Access Compliance Report

Public Rights-of-Way

(Curb Ramps)

Intersection ID: 5526	Main Street: COLLINS-AIKMAN_DR	Cross Street: UNIVERSITY_CENTER_BV	Location: W
ADA ID: 7E2CF3B8C3E4	Ramp Type: Perp	Initial Pass/Fail: Fail	Overall Compliance: No
Severity Score: 21.25			
Codes/Mitigation Info/Possible Solution		Field Measurements/Component Compliance

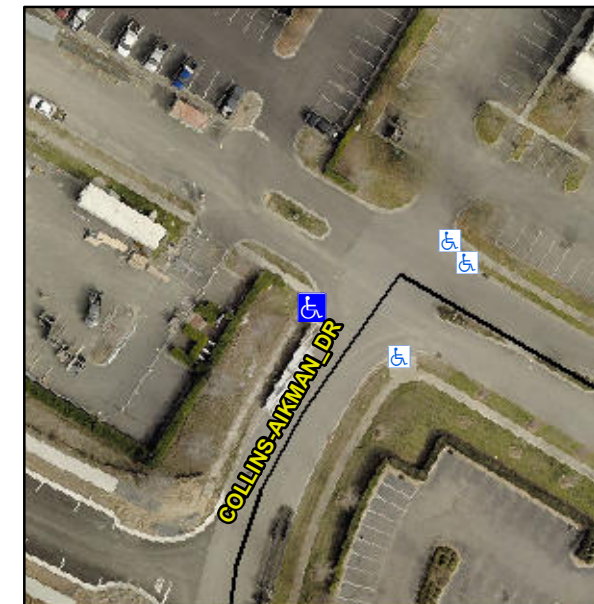
Not Found, R304.5.1, R304.2.2

Compliance	Description	Data	Compliance	Description	Data
N/A	Ramp Length (in)	68.0	No	Ramp Slope (%)	9.8
No	Ramp Width (in)	47.0	Yes	Ramp XSlope (%)	1.9
N/A	Flare Type LT	N/A	N/A	Flare Type RT	N/A
N/A	Flare Slope LT (%)	N/A	N/A	Flare Slope RT (%)	N/A
N/A	Flare Traversable LT?	N/A	N/A	Flare Traversable RT?	N/A
N/A	Landing Length (in)	N/A	N/A	DWS Provided?	N/A
N/A	Landing Width (in)	N/A	N/A	DWS Contrast?	N/A
N/A	Landing Slope (%)	N/A	N/A	DWS Length (in)	N/A
N/A	Landing X Slope (%)	N/A	N/A	DWS Full Width?	N/A
N/A	Landing Curb? (Y/N)	N/A	N/A	DWS Offset (in)	N/A
N/A	Shared Landing?	N/A			
N/A	Gutter Ponding?	N/A	N/A	Gutter Slope (%)	N/A
N/A	Gutter Lip Ht (in)	1.5	N/A	Gutter X Slope (%)	N/A
N/A	Painted X Walk1?	No	N/A	Painted X Walk2?	N/A
	X Walk 1 Direction	To SE		X Walk 2 Direction	N/A
N/A	X Walk 1 Width (in)	N/A	N/A	X Walk 2 Width (in)	N/A
	X Walk 1 Slope (%)	0.0		X Walk 2 Slope (%)	N/A
	X Walk 1 X Slope (%)	0.2		X Walk 2 X Slope (%)	N/A

Remove & Replace Entire Ramp.
